M42 Junction 6 Development Consent Order (TR010027) - Non-material change request

Change 1: Proposed change to the southern extent of the Limit of Deviation for Work No. 63 (Severn Trent Aqueduct)

Change 2: Attenuation Tank Relocation (Work No. 34)

Change 3: Parcels of land to be removed from the Order Limits

Appendix C – Land Plan Sheet 4

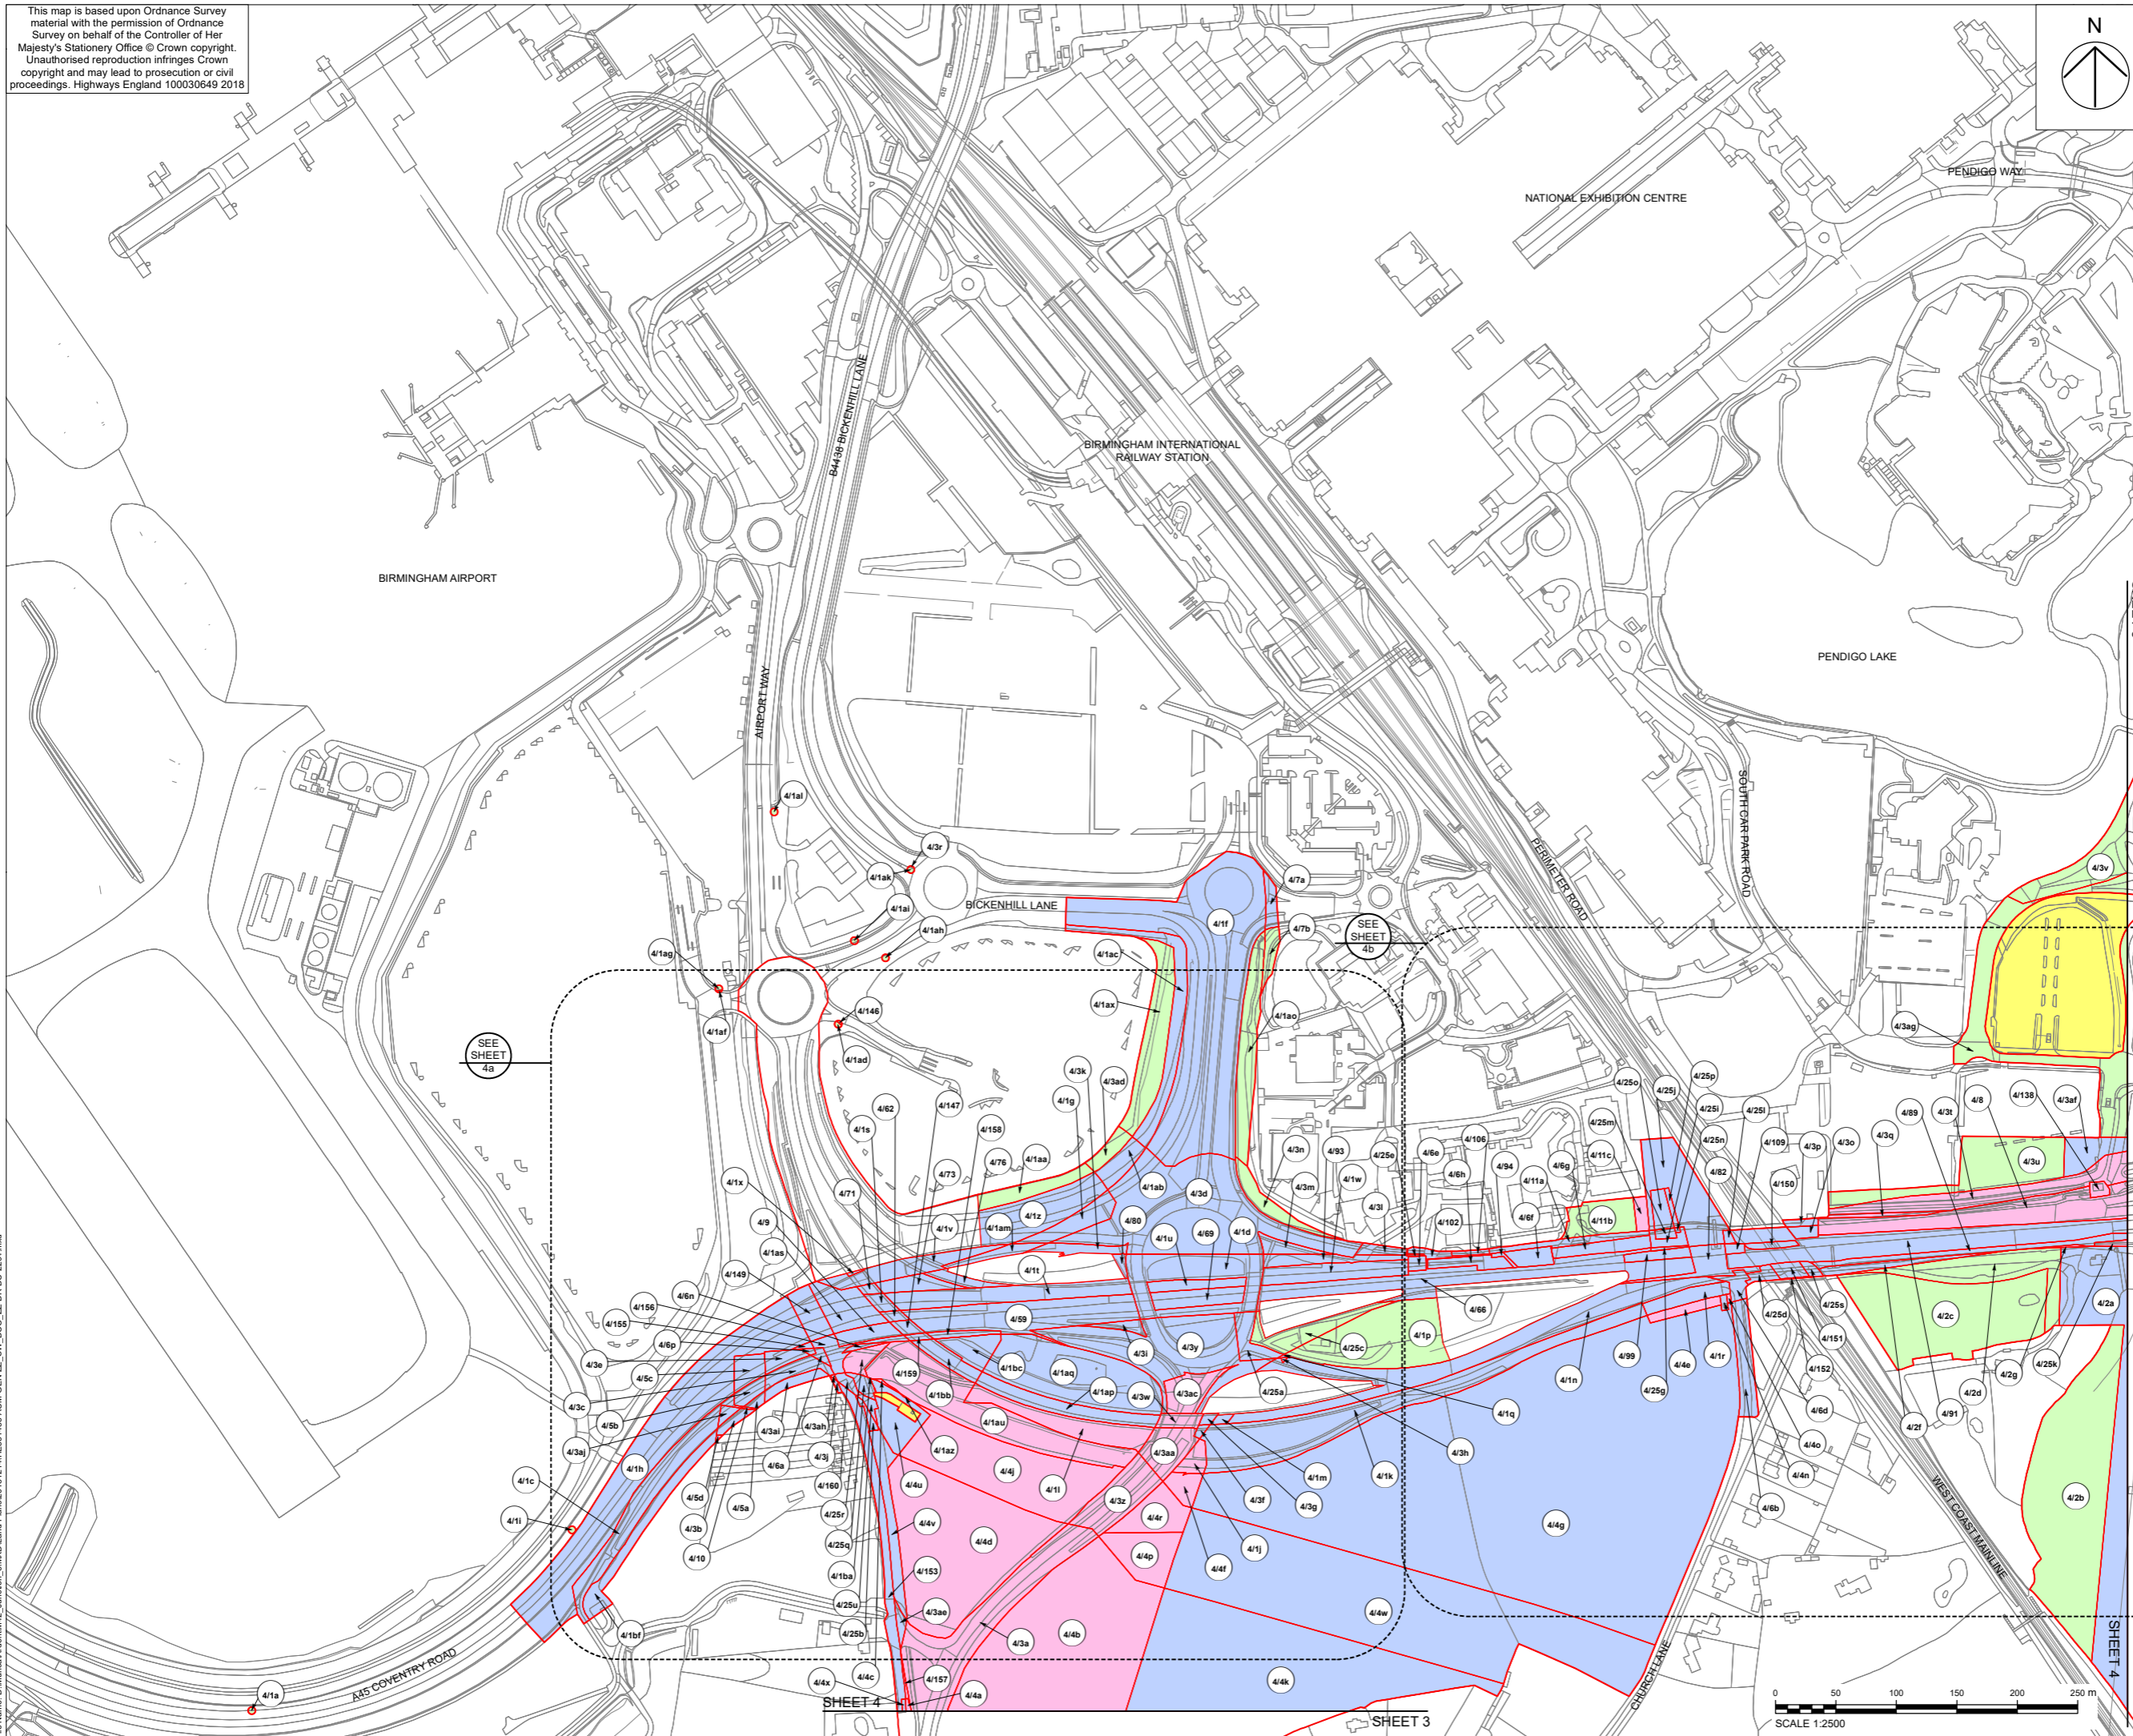
This would necessitate the southern extent of the Limit of Deviation (LoD) for Work No. 63 (see **Appendix B**) to move further south from parcel 4/4w, into parcel 4/4k (see **Appendix C**). Both parcels have the same landowner. Parcel 4/4k is already proposed to be used temporarily for the diversion of Western Power Distribution's apparatus, with permanent rights being sought under the DCO "*to construct, operate, access and maintain diversions to existing utilities apparatus and equipment*" [**APP-018 / Volume 4.1**].

Appendix E – Revised Works Plan Sheet 2

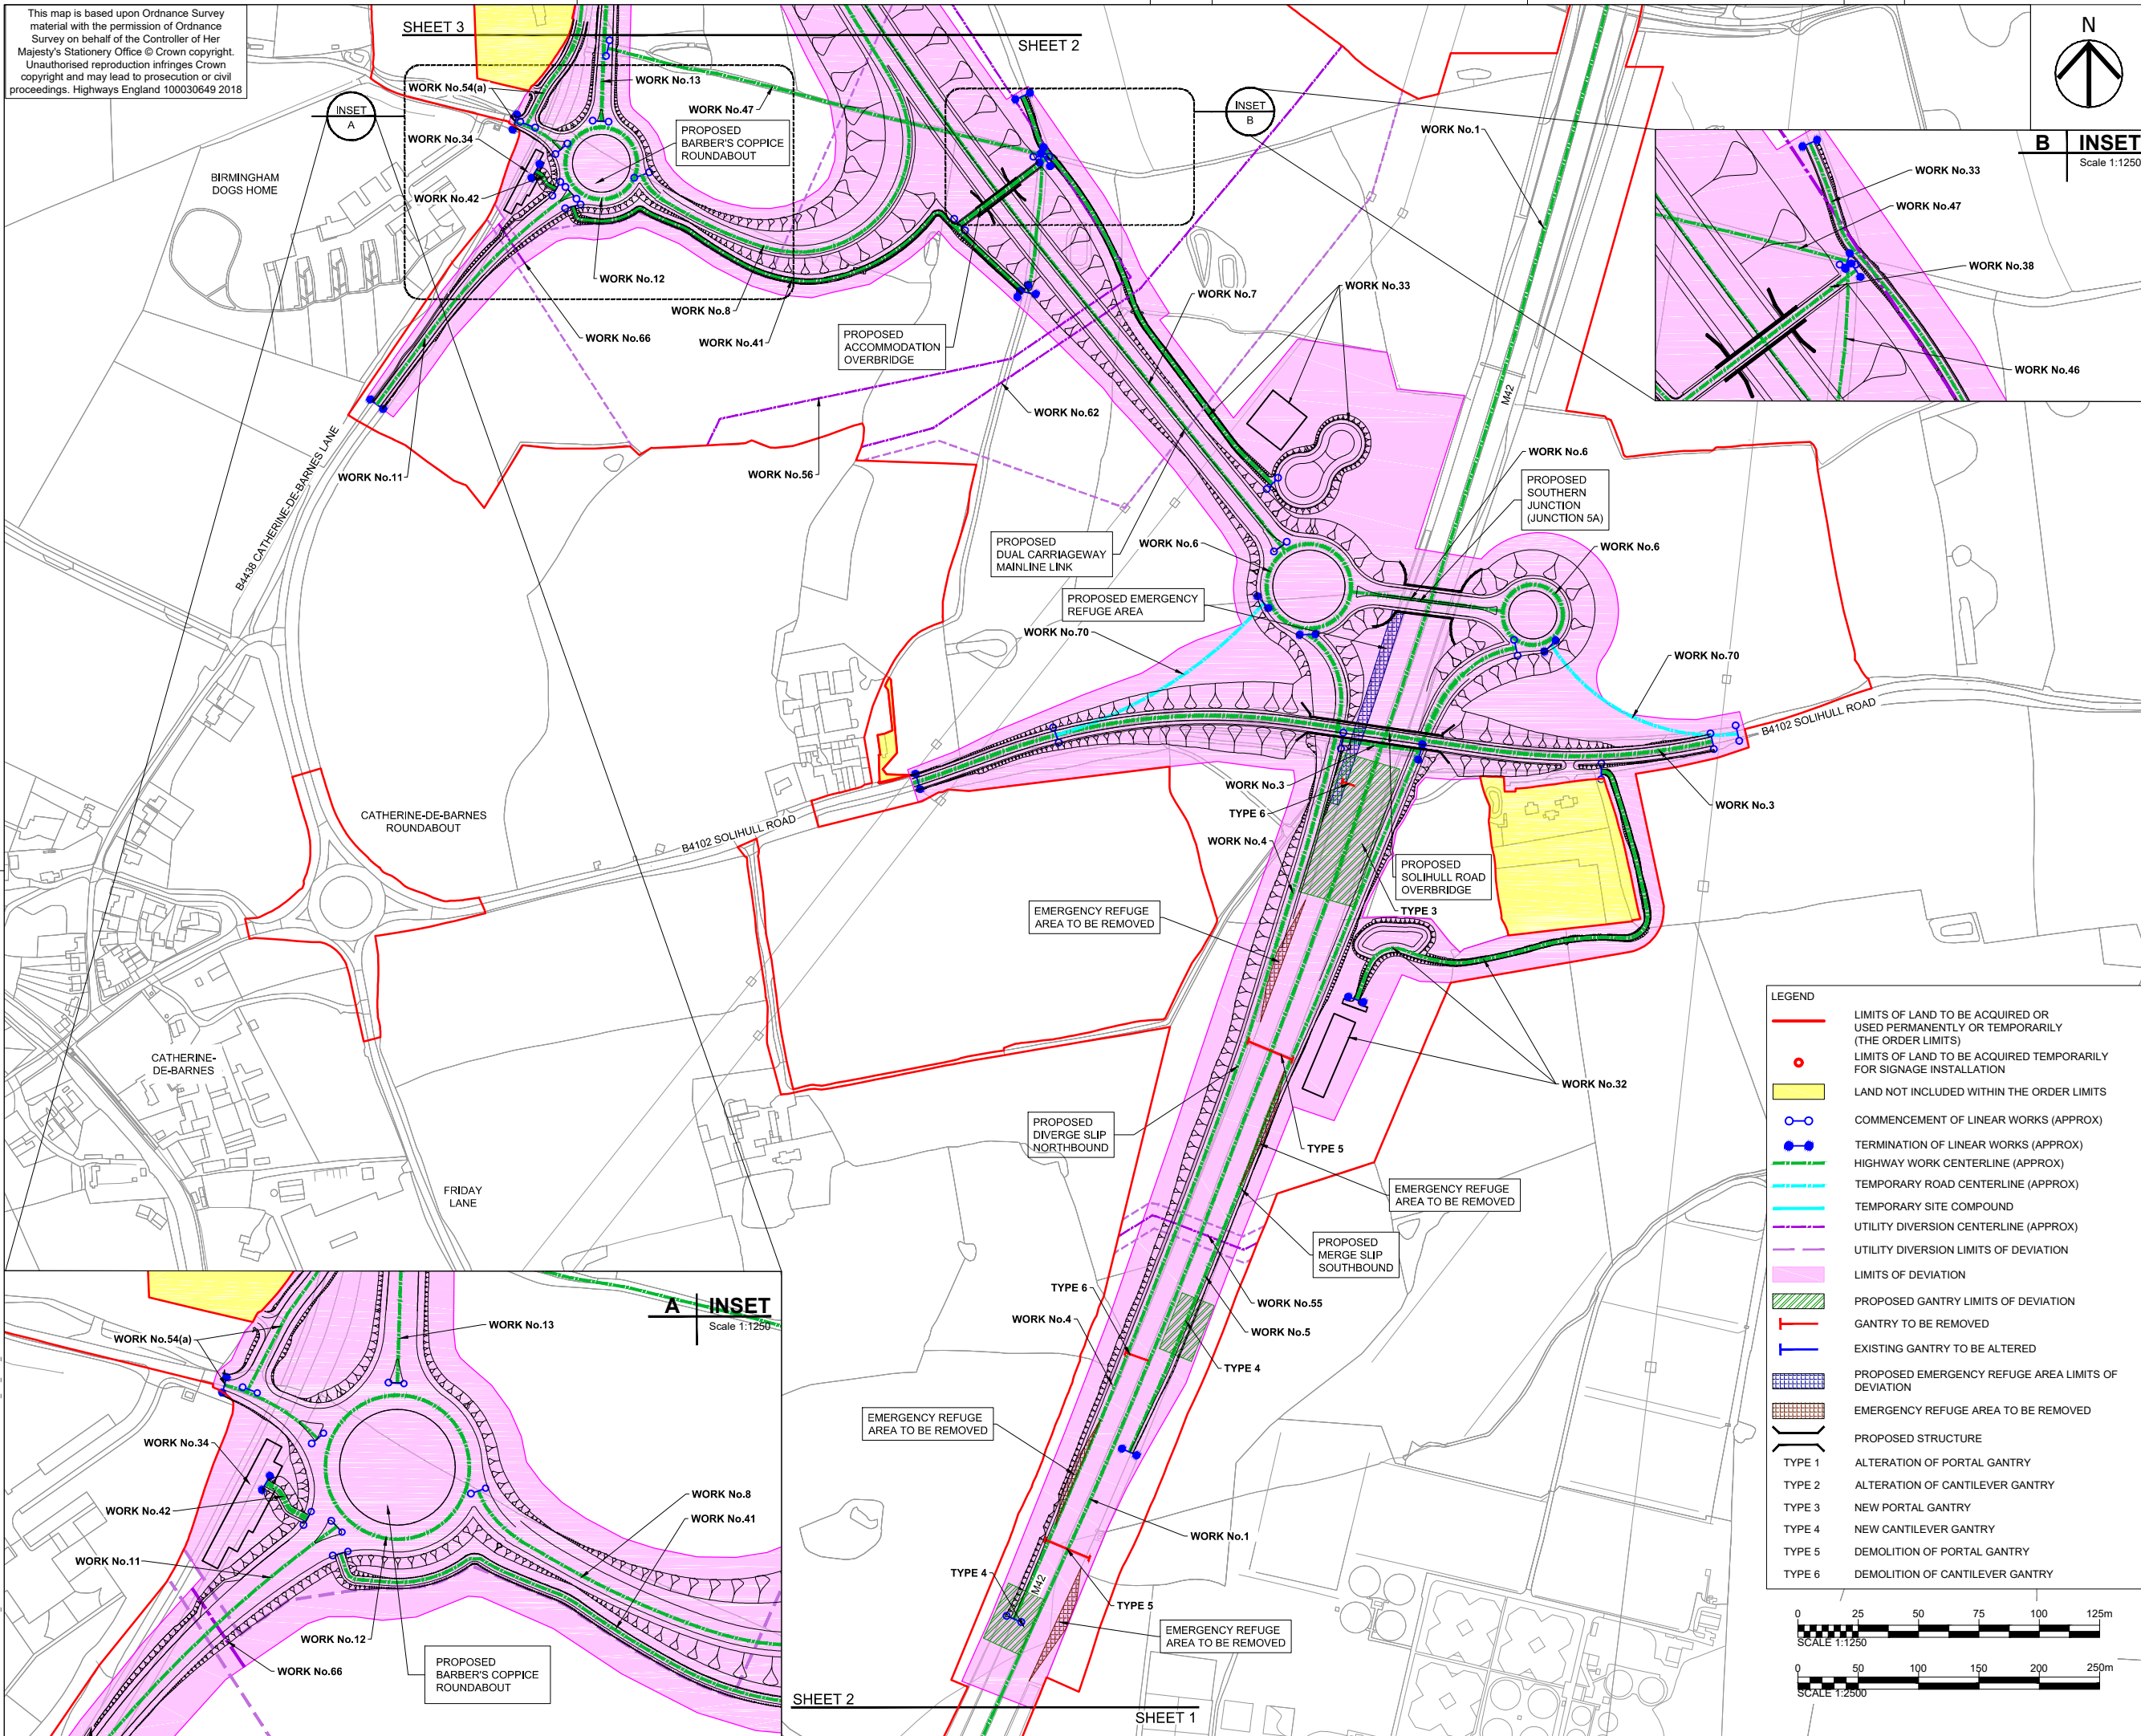
Following discussions with landowners and the local parish council, it is also proposed to change the location of, Work No. 34 (see **Appendix D**), a highway drainage attenuation tank, from the north western quadrant of Barber's Coppice Roundabout to the south western quadrant (see **Appendix E**).

In its existing location, the provision of a layby off the B4438 Realigned Catherine-de-Barnes Lane would be in close proximity to Barber's Coppice Roundabout where vehicles are leaving the roundabout travelling northbound. This location raises the following safety and operational concerns for the positioning of a maintenance layby:

- The lay by would be positioned whereby vehicles leaving the roundabout travelling northbound would be expecting vehicles ahead to be accelerating, not braking and undertaking a slow turning movement into a maintenance layby; and
- The position of the maintenance layby would be in a section of the Realigned Catherine-de-Barnes Lane where two lanes would be merging into one lane for vehicles travelling northbound. Subsequently vehicles merging into a single lane may be interrupted by a maintenance vehicle turning into the maintenance lay by.

As a result, the Applicant has proposed to move the attenuation tank to an area of land (parcel 2/10j and part of 2/71) (see **Appendix F**) which are already proposed to be acquired permanently to create new highway land, although they are outside the current LoD for Work No. 34.

The location has been proposed to mitigate the issues raised above by moving the attenuation tank south of Barber's Coppice Roundabout, where traffic will be decelerating on approach to the roundabout. Furthermore, the northbound lane on approach to the roundabout will be expanding to two lanes, reducing the risk of maintenance vehicles turning into a layby interfering with northbound traffic approaching the roundabout.
